June 30, 2015

FEMA LOMC Clearinghouse
Attention: LOMR Manager
847 South Pickett Street
Alexandria, VA 22304-4605

**RE: Case No. 15-06-0805R
Response to Request for Additional Information**

Geom: PINO ARROYO - EXST 2
RS = 2183.63

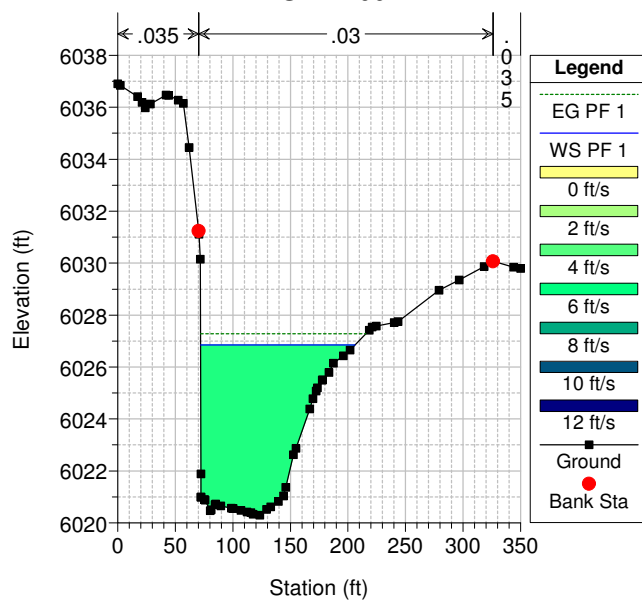
- d. *"Cross-Sections 2183.63 and 2200 are intersecting each other. Similarly, Cross-Sections 1942.35 and 1948.66 are also intersecting. Cross-Section 1948.66 is shown on the work map but not included in the hydraulic analysis. Please ensure that all cross-sections used in the hydraulic model are shown on the work map and do not intersect each other."*

I shortened Cross Section 2183.63 by 1' to make sure it doesn't overlap with Cross Section 2200. Thank you for bringing that to my attention.

RS = 1873.47

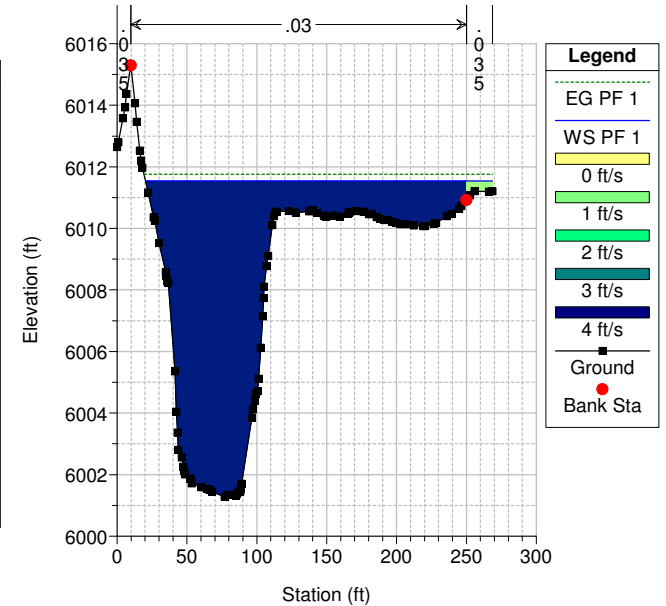
4. *"Our review revealed that the 1-percent-annual-chance Base Flood Elevations (BFEs) are higher than the end points of Cross-Sections 1873.47, 1086, and 1054.4 in the submitted existing conditions HEC-RAS hydraulic computer model and Cross-Sections 1086 and 1054.4 in the submitted proposed conditions HEC-RAS model along Pino Arroyo. The use of vertically extended cross-sections might both overestimate the BFEs and underestimate the width of the base floodplain. This issue was raised in our letter of January 7, 2015; however, no concrete justification was provided in this regard. Please revise the cross-section geometry coordinates so that the end points of all cross-sections are equal to or extend higher than the corresponding BFEs, or provide documentation that quantifies the amount of split flow that would occur if the cross-sections were not extended, and the extent of all flow breakouts."*

In the existing condition I extended Cross Section 1873.47 125' to the south. I also extended Cross Sections 1878.66, 1887.76, and 1891.58 at gradually decreasing increments to allow for a smoother transition between the Cross Sections.

Trapezoidal

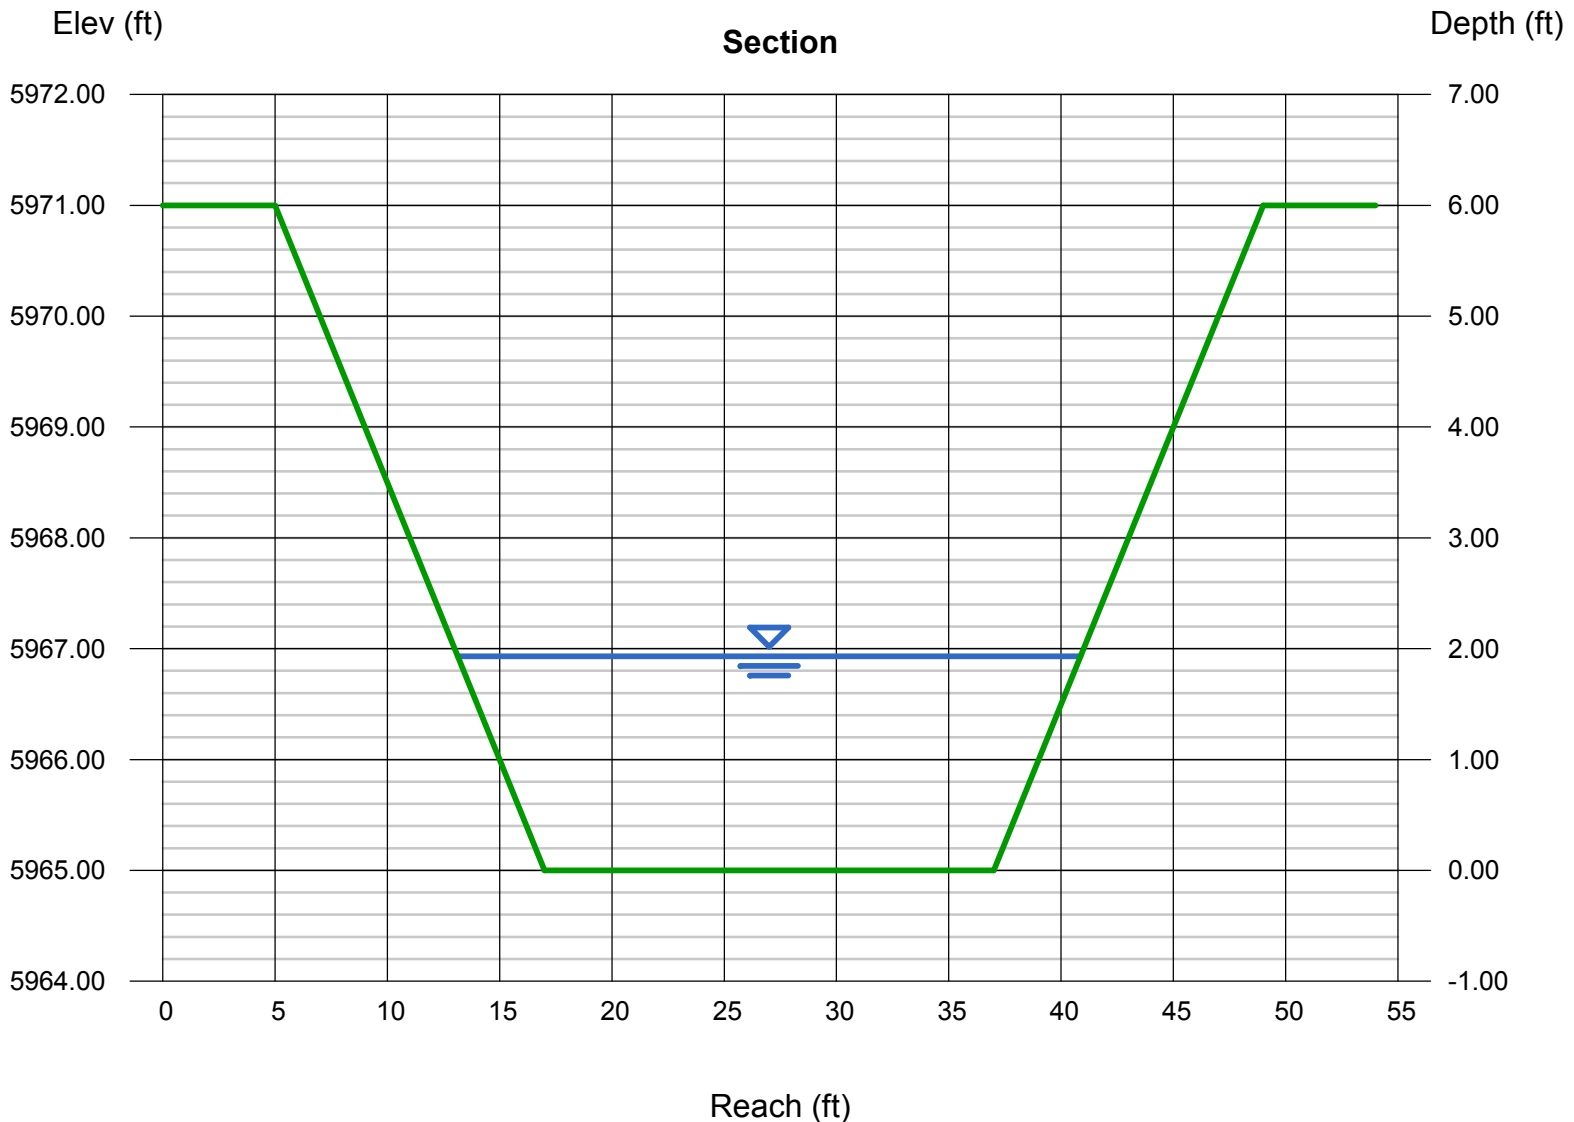
Cross Sections 1168.85, 1239.93, and 1251.03 cover the existing concrete rundown on the side slopes of the Pino Dam. This is a 6'± deep, 20' bottom-width, trapezoidal concrete channel at a 20% longitudinal slope. Manning's equation shows this portion of the arroyo as supercritical. (See attached.) When using the subcritical flow regime these cross sections all model as overtopping. I don't believe overtopping subcritical flows are the true existing condition, since there is no sign of erosion behind the edges of the rundown. (Even if it were actually subcritical, the overtopping flows would all be contained by the dam pool. They would not harm other nearby structures.)

1/5 of Existing 5-barrel CBC with Total Q=3,061 cfs

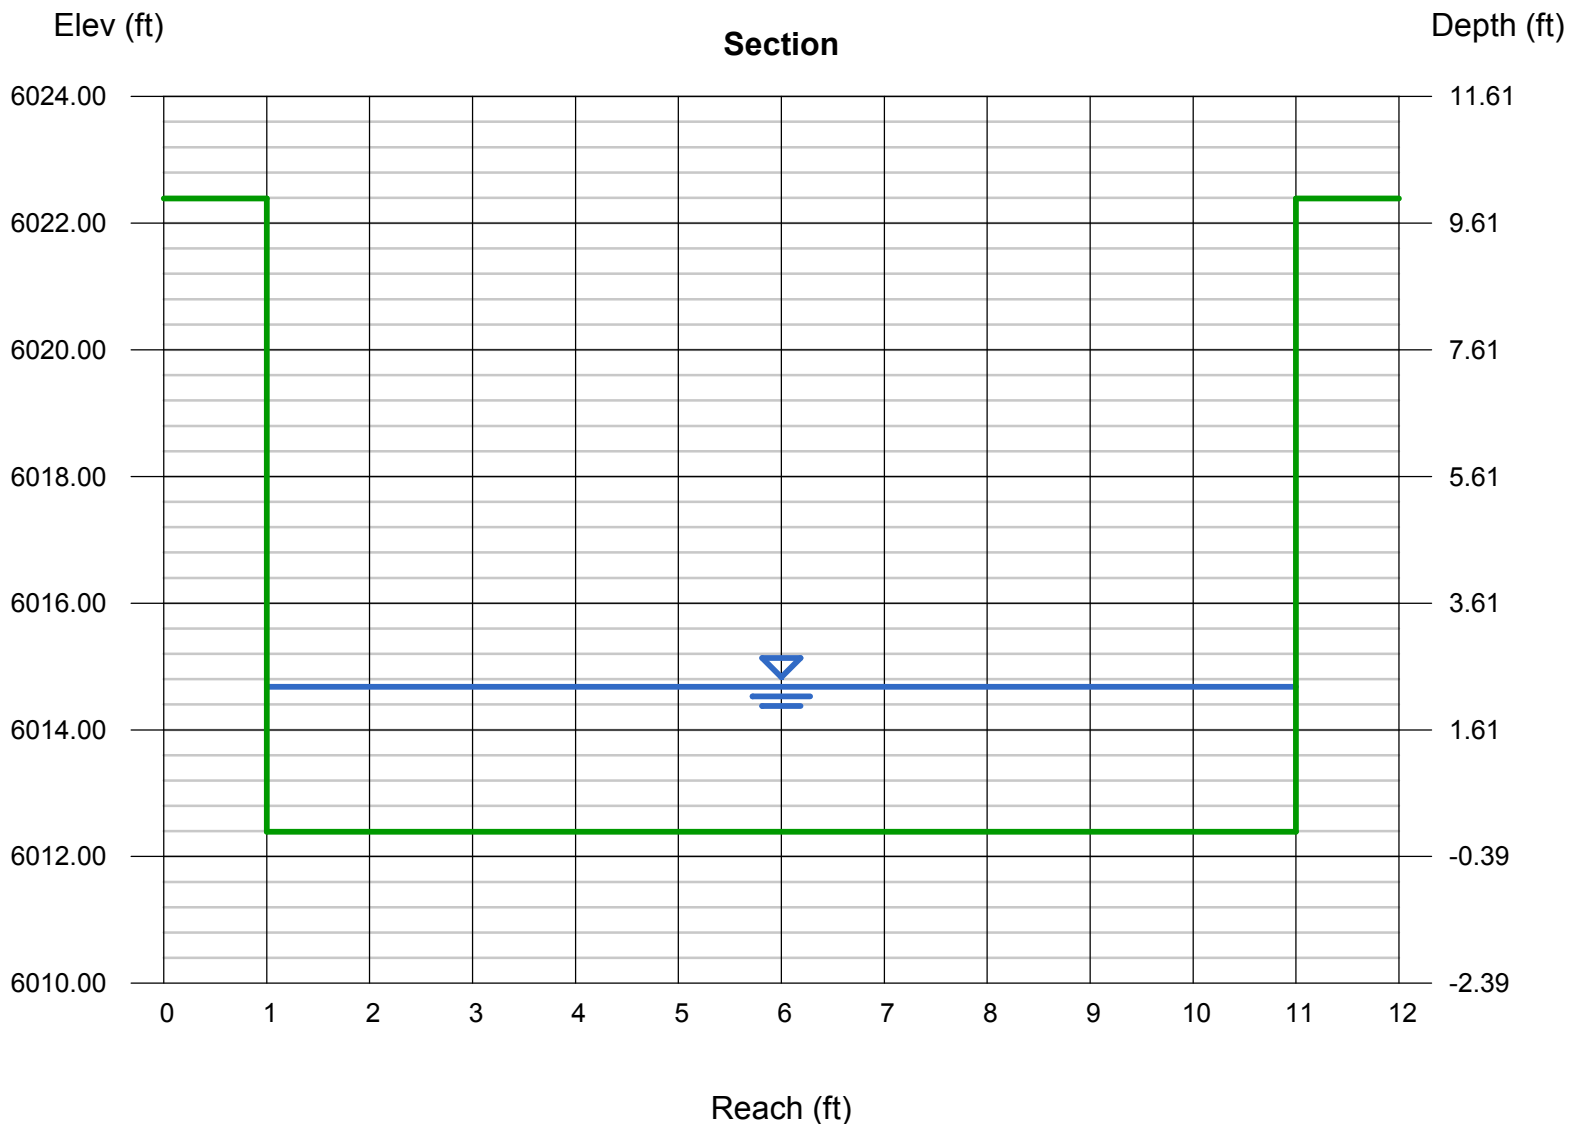
The steep slopes and high flows in the existing 5-barrel box culvert are also inconsistent with subcritical flow. I used Manning's equation to confirm that existing conditions are supercritical for one of the five 10'x10' barrels carrying 1/5 of the flow treated as an open channel. (See attached.)
